City of Rancho Palos Verdes
 Rancho Palos Verdes ADA Assessment
 Facility Report with Photos

Facility ID: # 02A - City Hall Grounds

Location: SE. of Admin. Bldg. Photo # 17

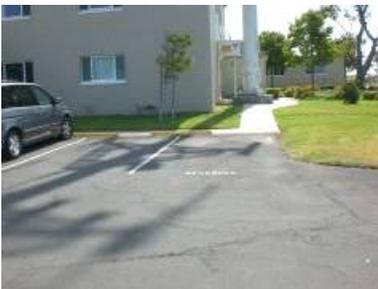
Keynote 17

Corrective Action
090A - Ramp with Handrails and Landings - Provide new compliant ramp with handrails, edge protection, and landings. Additional Comments:

Location: Photo #
 W. of Admin. Bldg. 17

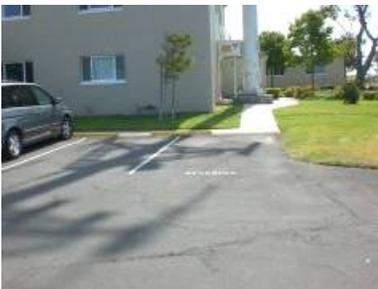
Keynote 19

Location: N. of Comm. Dev. Bldg. Photo # 26

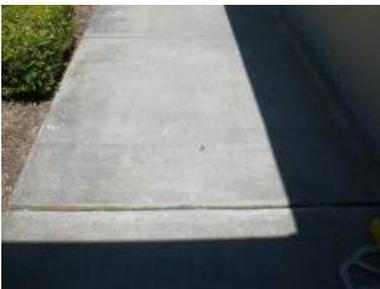
03B.12 - > 1/4" Changes in Level - Where walkway levels change abruptly, the vertical difference between them exceeds 1/4 inch. Or changes in level between 1/4 inch and 1/2 inch are beveled with a slope greater than 1:2.

Location: N. of Comm. Dev. Bldg.
Photo # 173

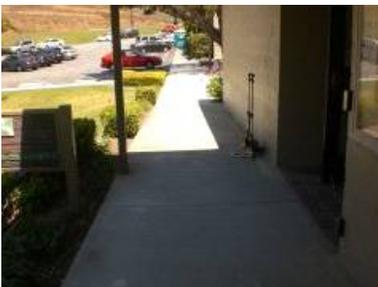
Keynote 173
